Elephant & Castle to Crystal Palace Quietway (QW7)

Turney Road

Main Consultation Issues and Responses

QW7 – TURNEY ROAD

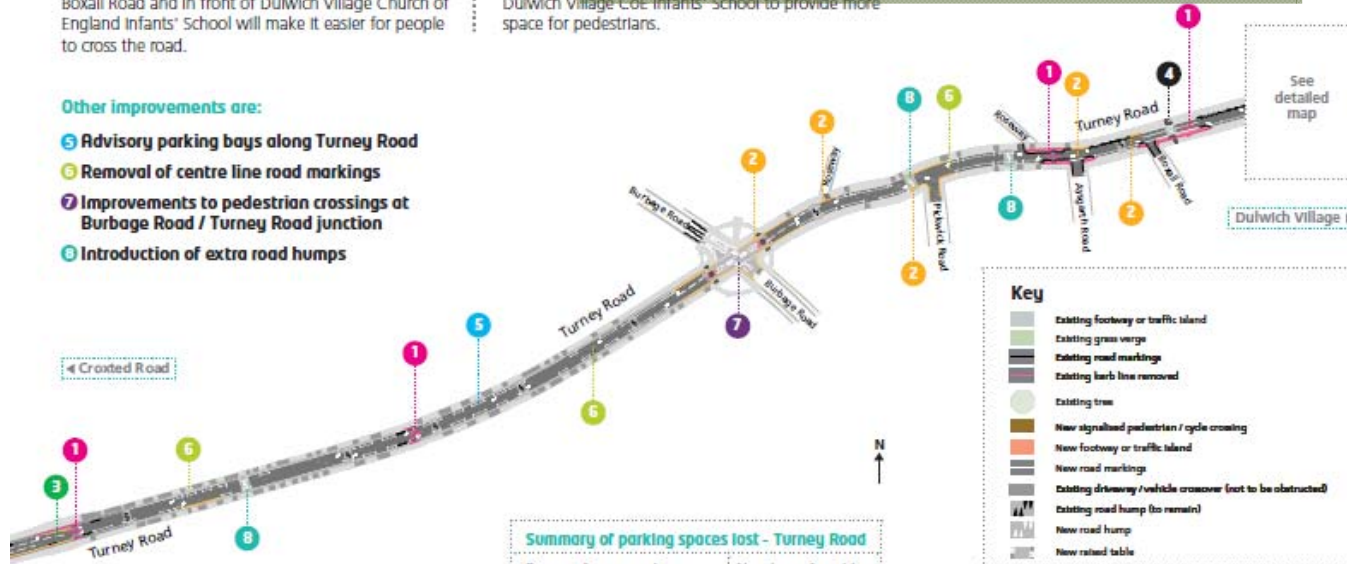
Swapping of traffic islands with footway buildouts	Traffic islands are safer than buildouts as they provide a two-phase crossing opportunity.	<p>Footway buildouts reduce the time pedestrians must spend in the road or in the middle of the road. Most of the existing traffic islands are not designed for pedestrians as they are less than 1.5m wide and do not include tactile paving. Hence, they do not provide adequate waiting widths and the provisions to accommodate large numbers of pedestrians, disabled users or parents with prams. Additionally, inappropriately parked vehicles can obstruct the visibility of pedestrians when crossing at the existing traffic islands.</p> <p>Traffic islands create pinch points and bring vehicles and cyclists into conflict, while build outs remove this conflict. Footway buildouts also encourage cyclists to maintain the primary riding position.</p>

Parking displacement on Burbage Road, Boxall Road, Aysgarth Road and Pickwick Road	<p>It is part of a LBS Borough-wide initiative to implement no waiting restrictions at any time (Double Yellow Lines) within 7.5 metres of a junction to ensure adequate visibility and increase safety for all road users. This addresses the conflicts between vehicles as well as vehicles and pedal cycles, and vehicles and pedestrians. It should be highlighted that obstructive parking practices and poor visibility at junctions are more dangerous for vulnerable road users, such as young children and people with disabilities.</p> <p>Proposals regarding parking restrictions have been reviewed and the proposed double yellow lines will be reduced to minimise parking loss, subject to any future road safety audits undertaken on the Quietway 7 proposals.</p> <p>Please refer to the Highway Code for more information on safe parking practises https://www.gov.uk/guidance/the-highway-code/waiting-and-parking-238-to-252</p>

Double yellow lines east of Croxted Road	Impact on nursery pick-up and drop-off times.	The extension of double yellow lines at Croxted Road is required to remove obstructions underneath the bridge that create pinch points and reduce the effective capacity on the approach to the junction.
Provision of marked advisory parking bays	Request for H-Bar Markings	The provision of H-Bar markings is against Southwark Council policy and as such, it is not recommended this is included in the proposals.
	Residents without off-street parking will have difficulty finding a parking space with the introduction of the parking bays.	The provision of marked bays was initially proposed as a visual aid demonstrating where it is safe to park without causing an obstruction. They would not have been enforceable, so no fines would have been issued. However, due to high levels of opposition, and re-examination of the proposals, this aspect will be removed from the design.

<p>Additional road humps</p>	<p>Already adequate traffic calming.</p>	<p>In order to discourage vehicle speeds in excess of 20 miles per hour along the Quietway 7 route, the spacing between existing road humps was reviewed. Three new sinusoidal road humps are necessary to ensure steady speed along Turney Road.</p> <p>Refer to <i>Traffic Calming</i>, LT N 1/07, DfT (https://www.gov.uk/government/uploads/system/uploads/attachment_data/file/329454/ltn-1-07_Traffic-calming.pdf) for more details on traffic calming techniques.</p>
<p>Removal of centre line road markings</p>	<p>Centre line is a good reference point and should be maintained for separation.</p>	<p>Due to the regularity of parked vehicles in Calton Avenue the effective road width is often reduced to <5.5m, as such, drivers might expect a road marked with a centre line to be wide enough for opposing lanes of traffic to pass. Removal of this centre line will promote safer driving behaviours, such as reduction in speeds along the route, and will support the existing 20mph speed limit.</p> <p>However, due to lack of support for this aspect of the proposals, the removal of the centre line marking will only be trialled where carriageway resurfacing will take place. Existing lines will be maintained elsewhere along the route.</p> <p>TfL has recently published related research highlighting the above, which can be accessed online at the following link http://content.tfl.gov.uk/centre-line-removal-trial.pdf</p>
